DEVELOPMENT REVIEW BOARD  
SUPPLEMENTAL SUBMITTAL

PROJECT NO. 2018-001579

This letter outlines the modifications that have been made to the Apartments at Pennsylvania and Indian School application for a major site plan amendment to the approved Winrock Town Center Site Development Plan (PR-2018-001579) to address the agency comments that were received.

APARTMENTS AT INDIAN SCHOOL & PENNSYLVANIA  
 7500 INDIAN SCHOOL RD NE  
 ALBUQUERQUE, NM, 87110

DRAWN BY	D/P/S
REVIEWED BY	D/P/S
DATE	02.05.2021
PROJECT NO.	19-0087
DRAWING NAME	SITE PLAN

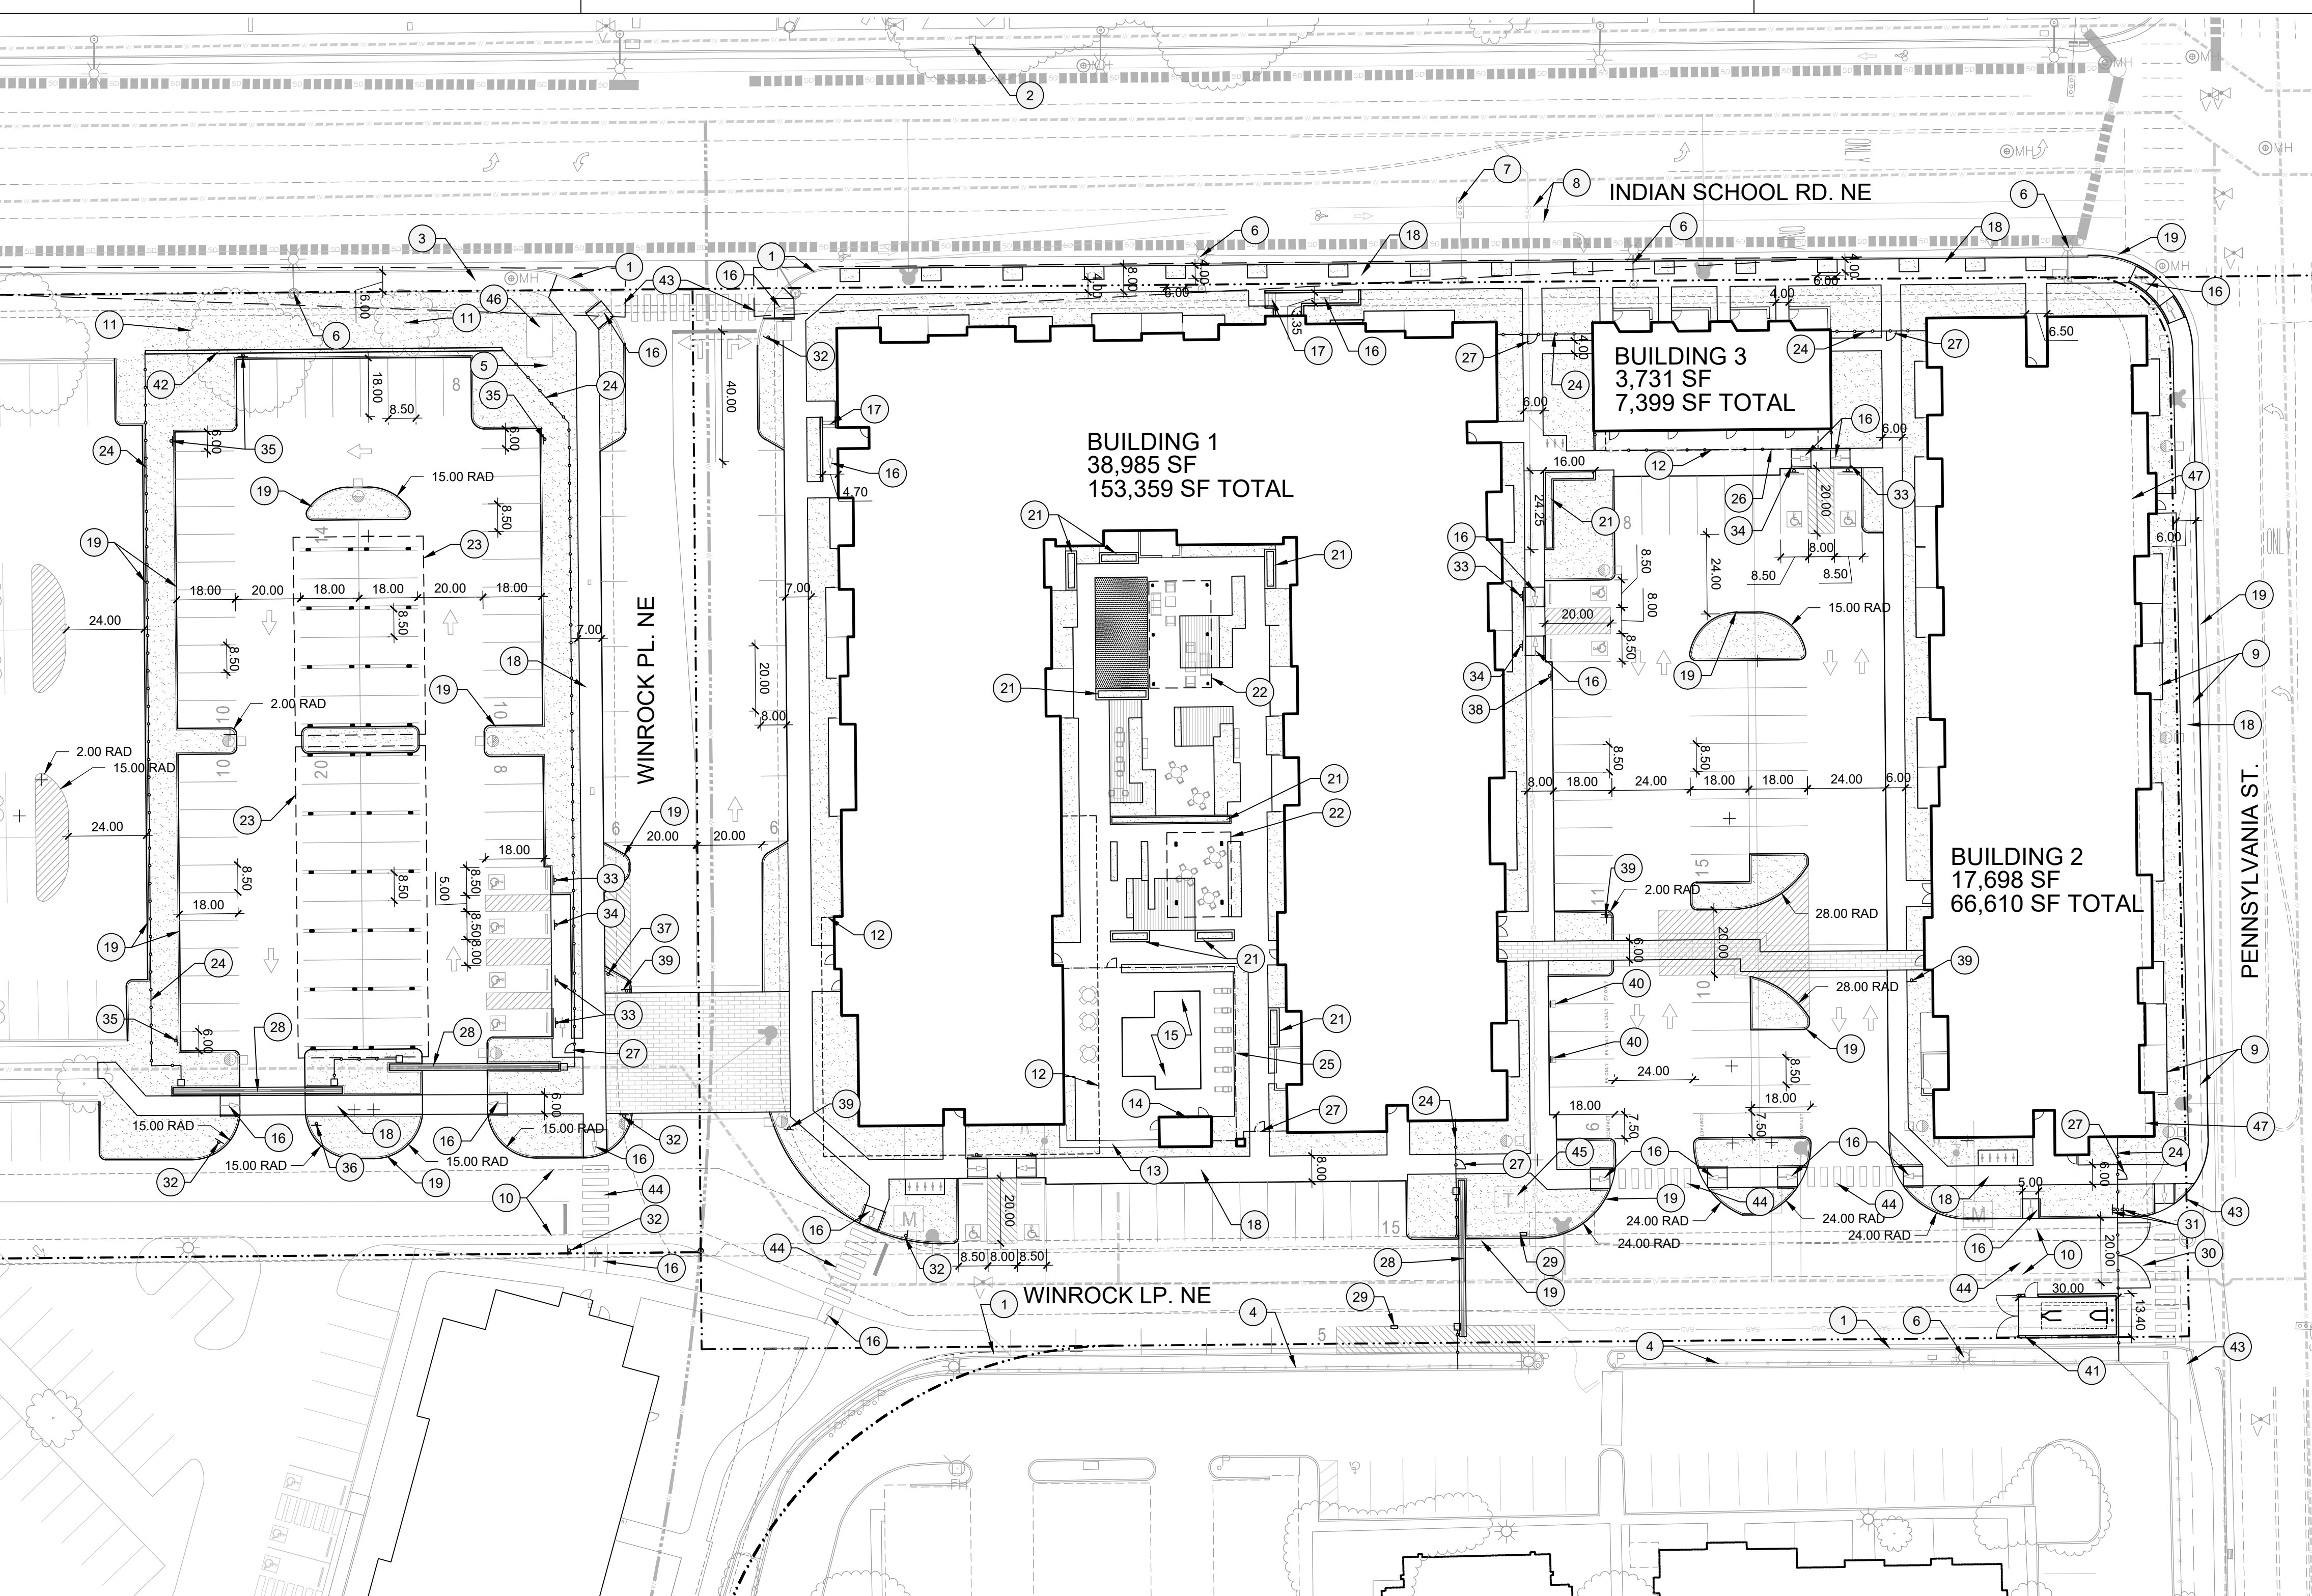
- 5. In lieu of two crosswalks close together, provide one crosswalk that is close to the intersection.**

- 7. What type of traffic control shall be provided at the Winrock Loop intersection? Provide stop signage and stop bars as needed. (Coordinate with Modulus on plan set so there is not any overlap.)**

- 8. Clear sight triangles based on speed limits per the new DPM shall be shown; adjust landscaping as needed. Show matching clear sight triangles on site plan and landscaping plan.**

- 9. Include "Emergency Access Only" signage on each side of the drive off of Pennsylvania. Include Knox box and Fire Marshall approval.**

- 11. Where are the electrical charging stations and the bike rack? Meet standard dimensions for bike rack per the IDO.**

*The two crosswalks have been combined into a single raised crossing similar in width to the raised crossing at Winrock Town Center Regal Cinemas.*

*Please see response in item #6. In addition, the applicant has revised the site plan to add stop bars, pedestrian crosswalks, and stop signage.*

*The applicant has added clear site triangles per DPM at the intersection of Winrock Loop and Indian School per meeting discussion with Jeanne Wolfenbarger on Tuesday, January 26<sup>th</sup>, 2021. Landscape plan has been adjusted accordingly. Adjustments made to direct access from the site onto Indian School Rd, due to the assignment of "emergency exit only" onto Pennsylvania St, modified clear sight triangles were not applied as this is not considered an intersection.*

*The applicant has added “emergency access only” signage on each side of closed off driveway. Signage detail is added to the SDP1.2 sheet. An approved Fire One plan has been obtained for the site. Knox box shall be included per the fire marshal’s requirements.*

*Electric Vehicle (EV) charging stations are located at the southwest corner of the east parking lot and marked by keyed note 40. Bike racks are shown on the legend and detailed on SDP1.2 per IDO requirements.*

LANDSCAPE  
PLAN

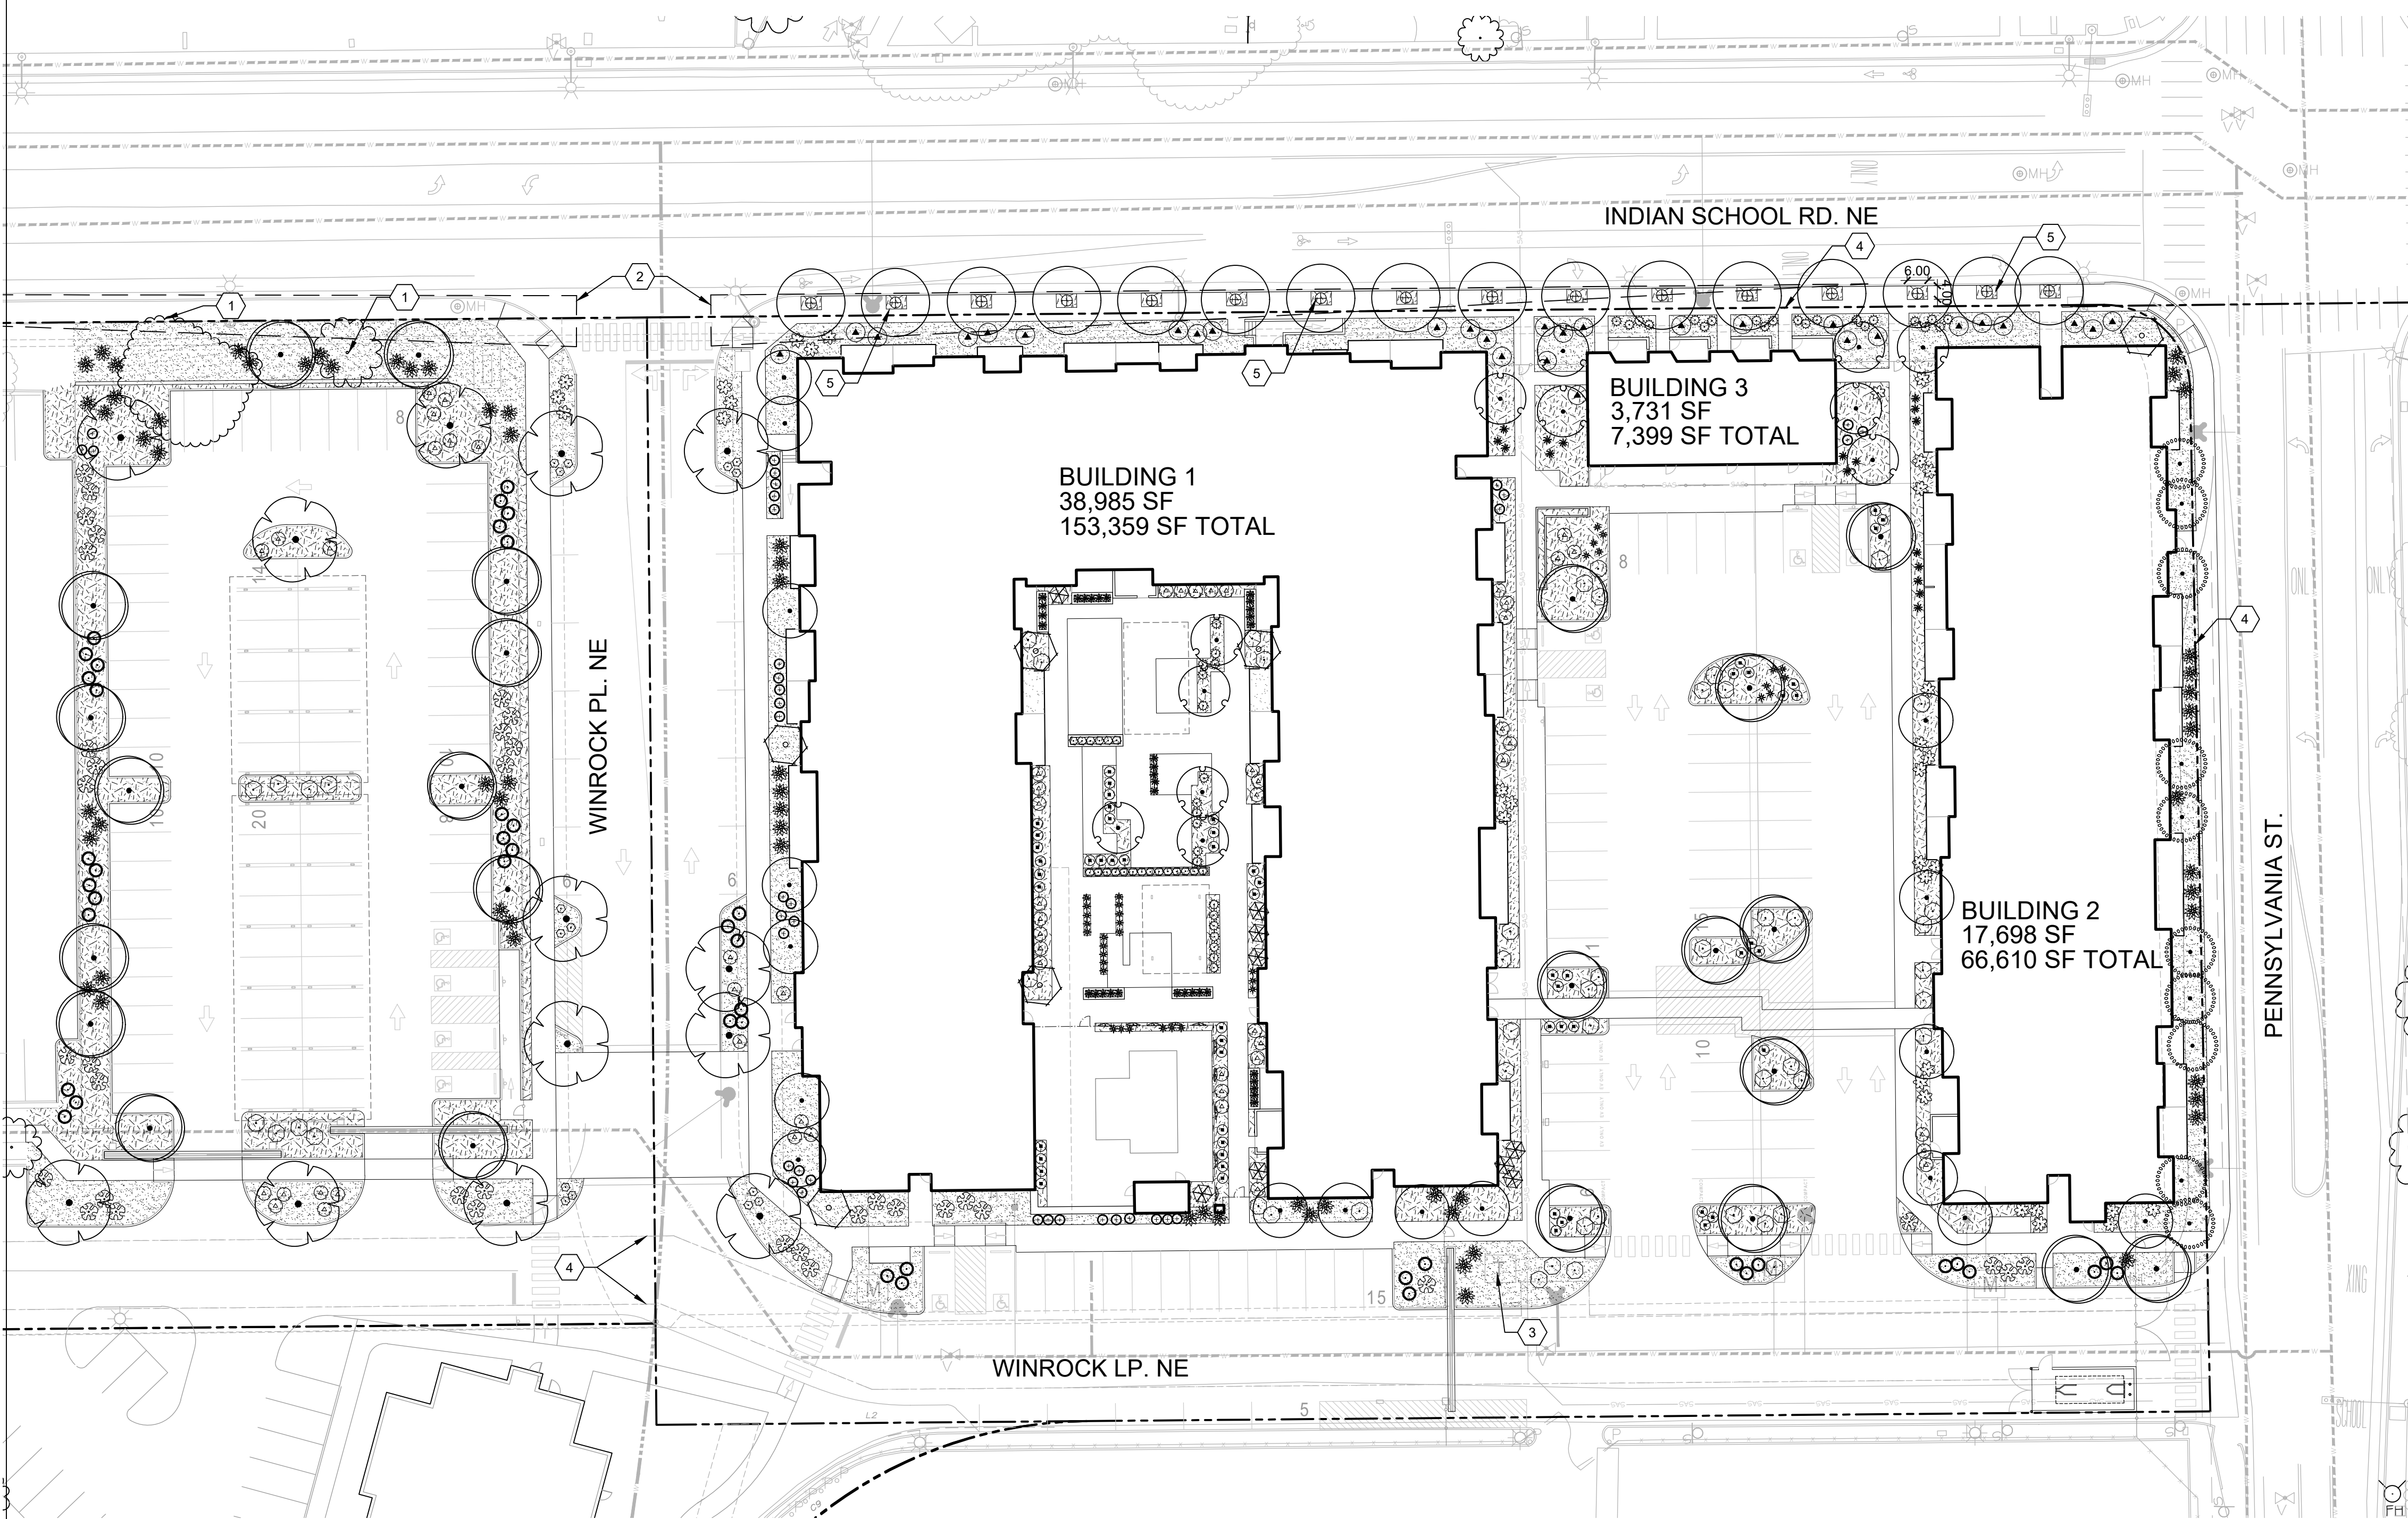
- 1. Indian School is a Minor Arterial and Pennsylvania is a Minor Arterial, both requiring street trees. The Site Plan does not appear to show street trees on Indian School to the west of Winrock Loop NE.**

- 2. Tree selection should include species from Official Albuquerque Plant Palette or provide documentation for drought tolerance – concern with Frontier Elm and Eastern Redbud.**

- 14. Confirm that all plant species are on the City's plant list.**

*The applicant has revised the landscape plan to add street trees. Due to existing mature trees on site, which are proposed to stay and be protected during construction, only limited amount of street trees can be added. Applicant is using credit for preserving trees per IDO Table 5-6-2.*

*The applicant has revised the landscape plan to ensure that all plant species utilized are on the City’s plant list.*

*The applicant has revised the landscape plan to ensure that all plant species utilized are on the City's plant list.*
